SUBJECT: ISSUANCE OF AMENDMENT NO. 169 TO FACILITY OPERATING LICENSE
NO. NPF-6 - ARKANSAS NUCLEAR ONE, UNIT NO. 2 (TAC NO. M92064)

AMENDMENT TO FACILITY OPERATING LICENSE

Amendment No. 169
License No. NPF-6

ATTACHMENT TO LICENSE AMENDMENT NO. 169

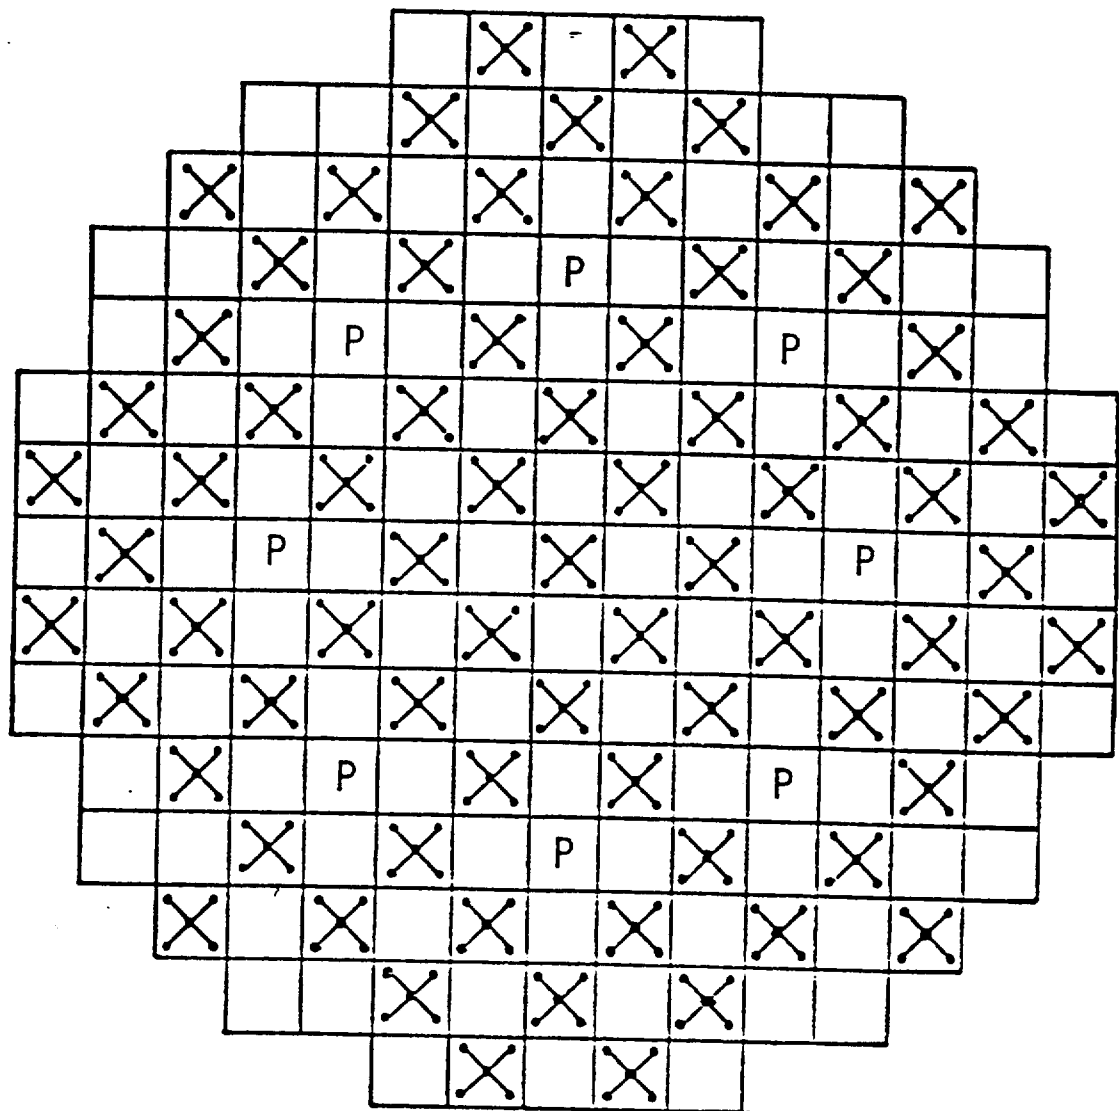
5.3.2 The reactor core shall contain 81 control element assemblies.

- FULL LENGTH CEA's 73

- PART LENGTH CEA's 8
 TOTAL = 81

In addition to the 73 full length CEAs, the ANO-2 reactor currently contains eight PLCEAs. The PLCEAs contain full strength neutron absorber sections in only the upper 10% of their length and are intended to provide control of axial power distribution. By the end of the current fuel cycle, Cycle 11, the CEAs will have operated to the end of their evaluated design life and will be replaced during the refueling outage. During this outage, the licensee will also replace the eight PLCEAs with full length CEAs and will designate this as Group P CEAs.
